# Access Compliance Report

## Public Rights-of-Way

Intersection ID: 7805	Main Street: HIDDEN_VALLEY_RD	Cross Street: WHITE_PLAINS_RD	Location:	E
ADA ID: 5A780BDF9F90	Ramp Type: Combination1	Initial Pass/Fail: Fail	Overall Compliance: No	Severity Score: 8.75
Codes/Mitigation Info/Possible Solution		Field Measurements/Component Compliance

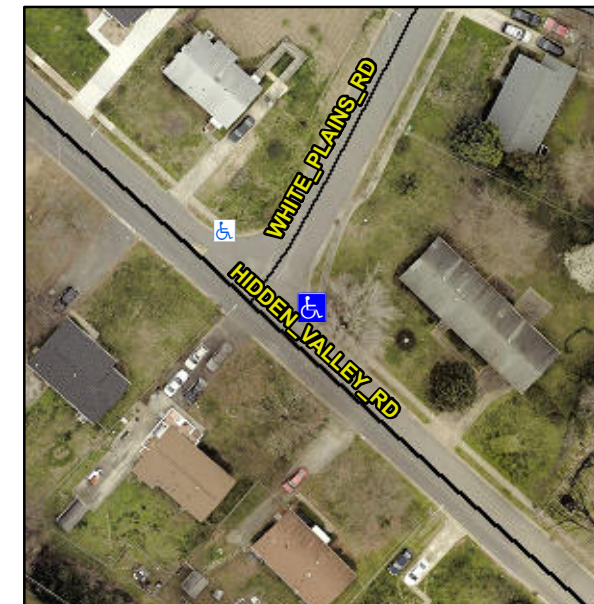
**GTR LIP 2.0, RT RP < 5%**

**Not Found, R304.5.1, R304.5.1**

**Remove & Replace Entire Ramp.**
